A Home for John Balz and Erica Simmons
25 North Prospect Avenue - Madison, Wisconsin
17 December 2012 - Addendum

Thomas Phifer and Partners

December 17, 2012

Driveway Access
to Garage

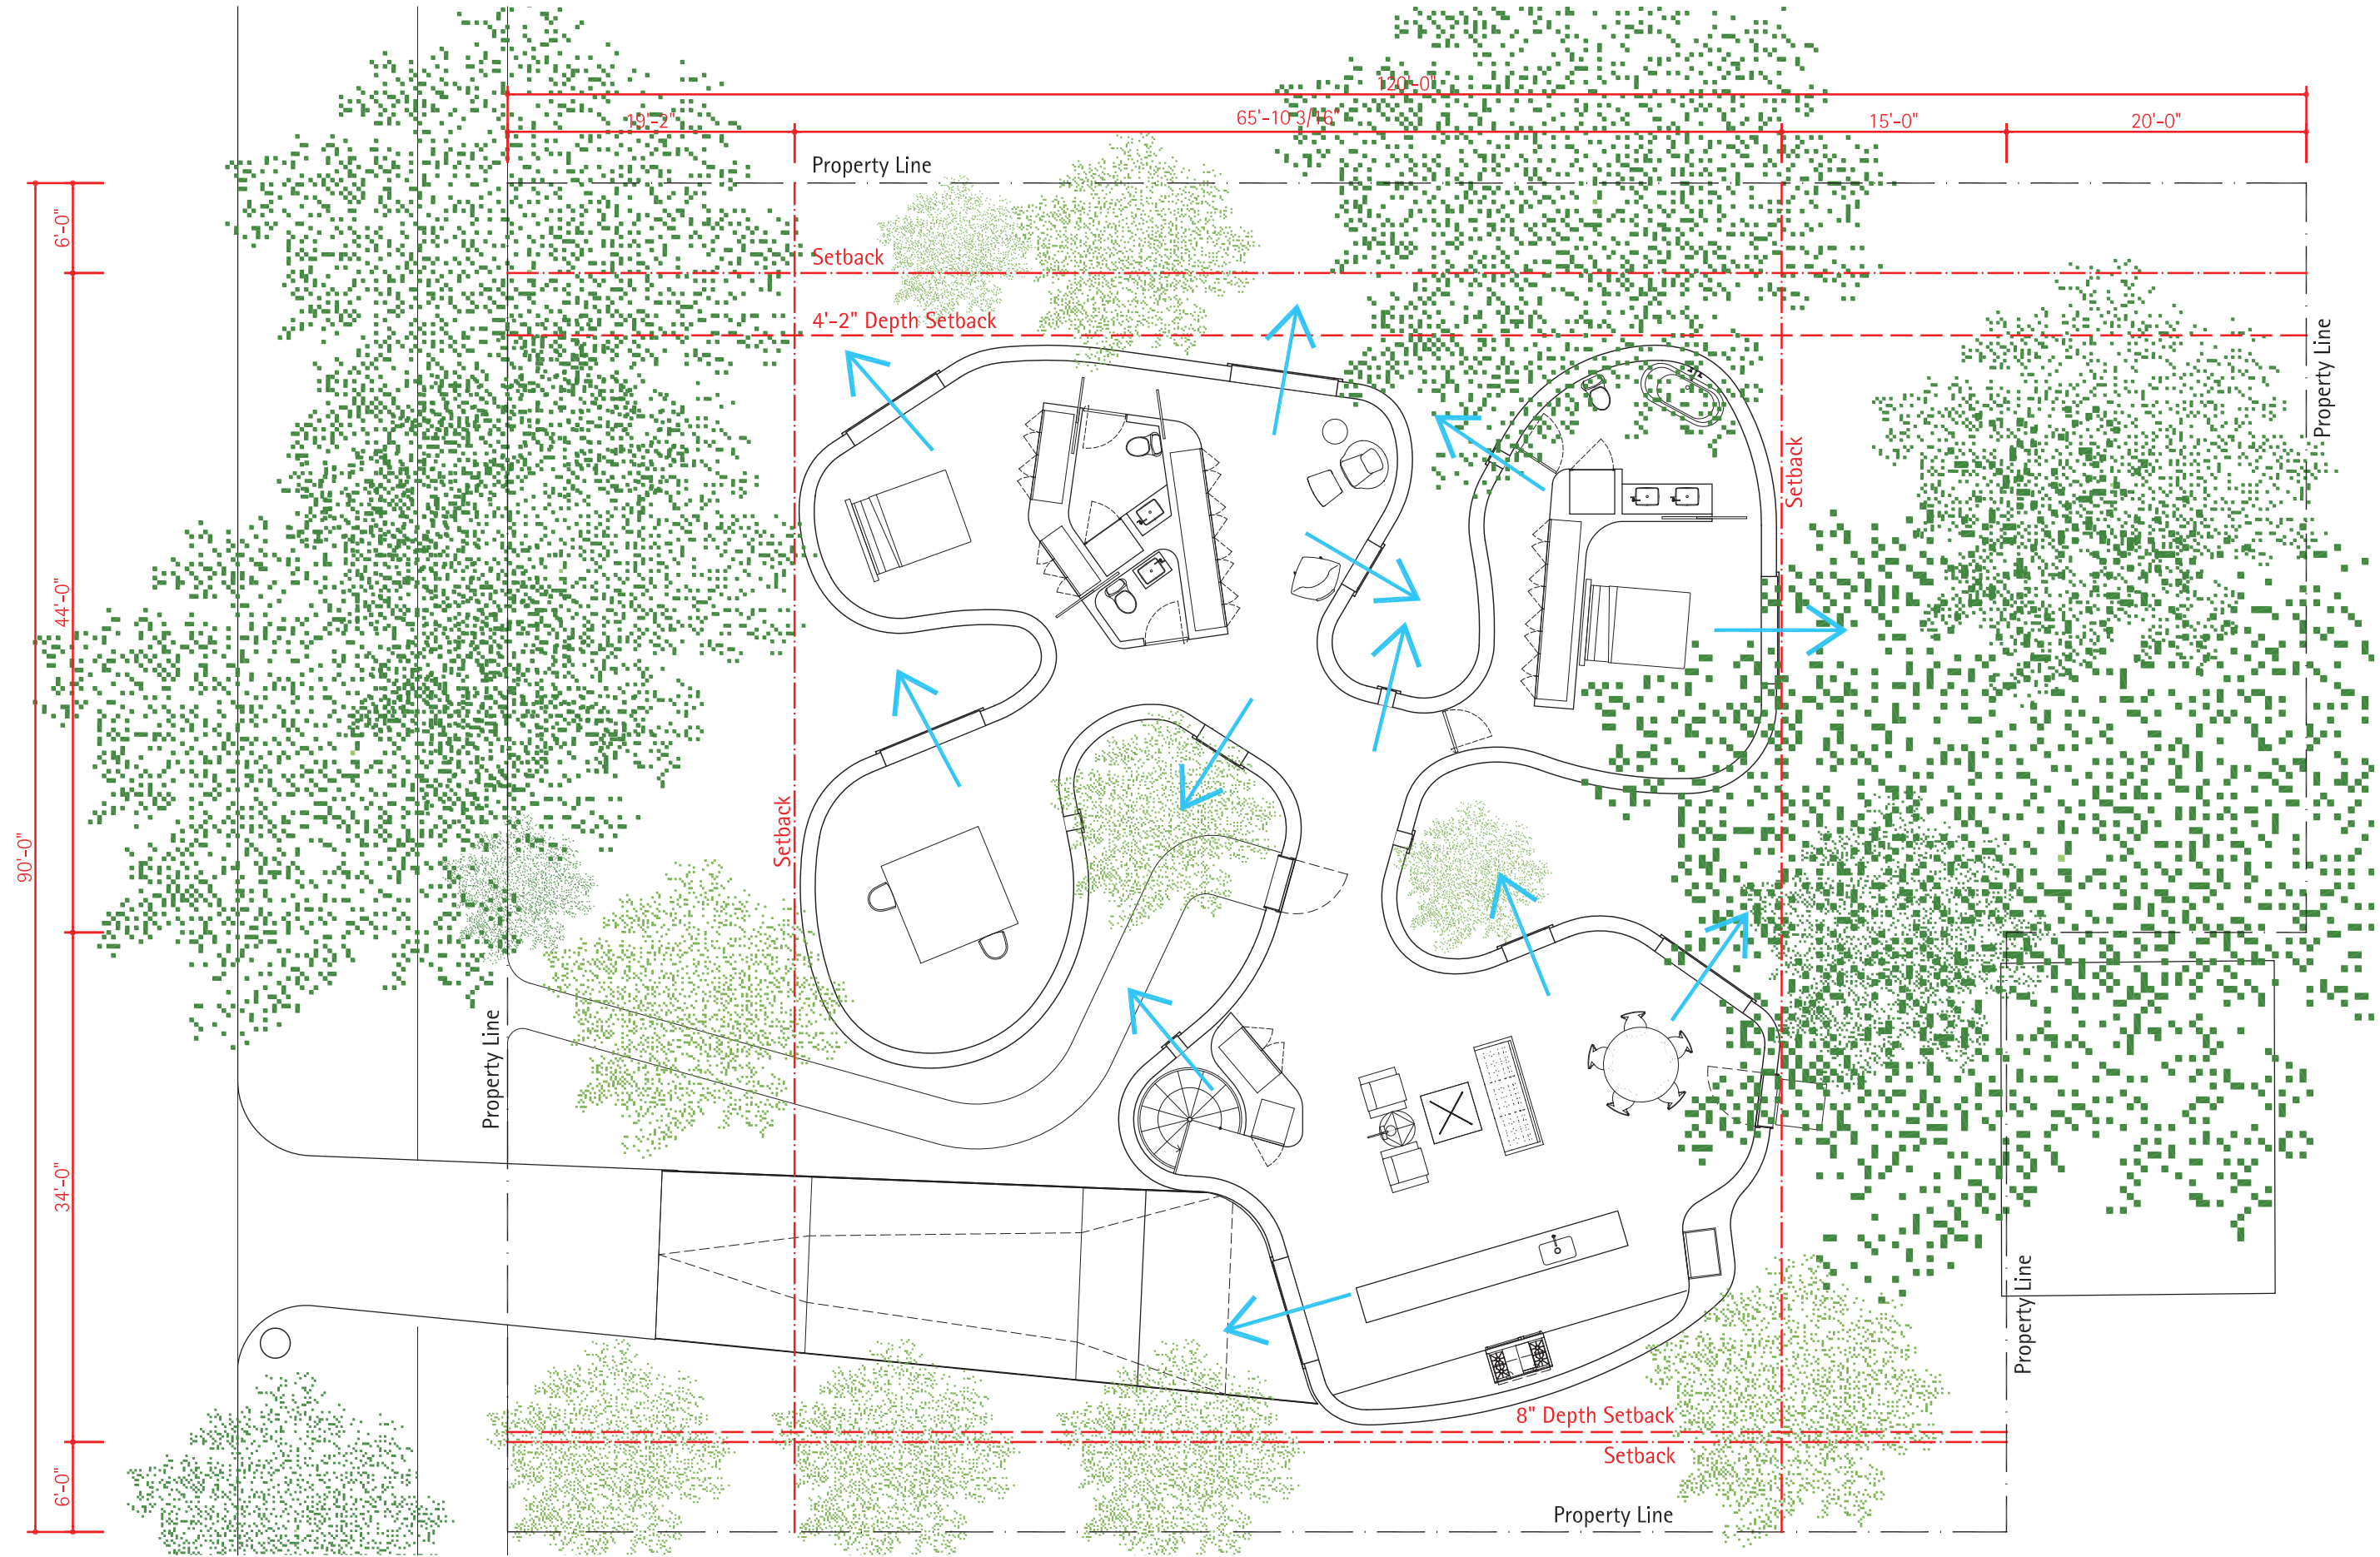
1. The driveway to the basement garage is designed to minimize the amount of paved area visible from the street. The required guardrail serves to obscure views of the pavement and the garage door. The material of the guardrail and canopy is complementary to the palette of brick used for the exterior of the house and will be dark metal, such as found on the Bradley House nearby.
2. The front door entrance will be recessed in a wood frame without any additional canopy projections.
3. Skylights are low profile and of approximately the same height as the building parapet, making them barely visible from street level.
4. The garage door will be a residential sectional steel garage door, painted in a dark color to minimize its visual impact and will be further obscured by the submerged driveway and guardrail elements.
